CALIFORNIA COASTAL COMMISSION

August 27, 2001

RE: **Notice of Impending Development 3-01, Pursuant to the University of California Santa Barbara Certified Long Range Development Plan (LRDP) for Public Hearing and Commission Action at the meeting of September 11, 2001, in Eureka.**

SUMMARY AND STAFF RECOMMENDATION

| Coastal Access Parking Location |

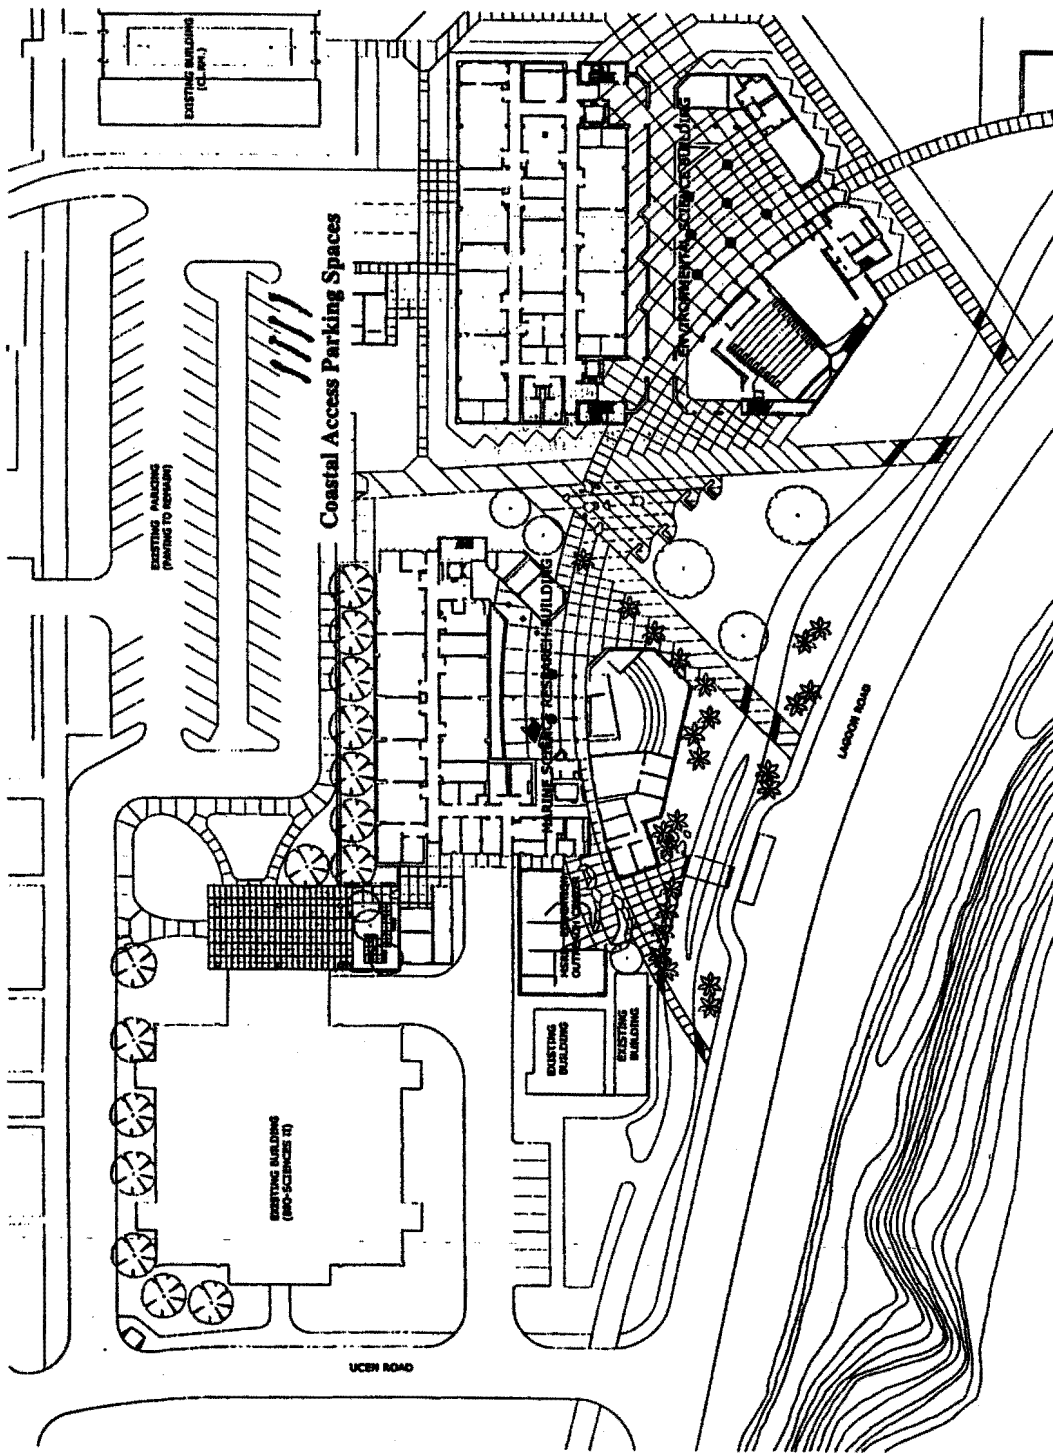
Within 30 days after the completion of construction activity, the University shall conspicuously post signs at each of the four designated public coastal access parking spaces in Lot 1 which clearly state that the parking spaces are reserved for public coastal access parking only. If parking meters are used in conjunction with the designated public coastal access parking spaces, then such meters shall allow for a maximum parking time of at least four hours at a rate equivalent to that charged by other parking meters located on campus, but in no instance shall the total parking fee charged for the 4-hour maximum use time exceed 4/5 of the fee charged for a one-day campus parking permit. Prior to the commencement of development, the University shall submit, for the review and approval of the Executive Director, the wording to be used for all signage.

To ensure that these requirements continue to be applied to the relocated coastal access parking spaces and to ensure that beach users would be able to use the parking spaces that are specifically designated for the provision of coastal access, the Commission is requiring **Special Condition Six (6)** which addresses coastal access parking signage, parking length, and fee. The Commission notes that Special Condition 6 will maintain the current ratio between parking fees charged for metered stalls and permit parking fees on campus. Current parking fees on campus are the same whether visitors purchase a parking permit or use a metered stall: a daily parking permit costs \$5.00, a 3-hour permit costs \$3.00, and a 30 minute permit costs 50 cents (4-hours of metered parking = \$4.00 or 4/5 of the fee charged for a one-day campus parking permit). Further, in order to minimize competition with campus faculty and students for parking spaces, Special Condition 6 also requires the University to post signs at each of the four parking spaces in Lot 1 that are specifically designated for the provision of coastal access which clearly state that the parking spaces are reserved for public coastal access parking only.
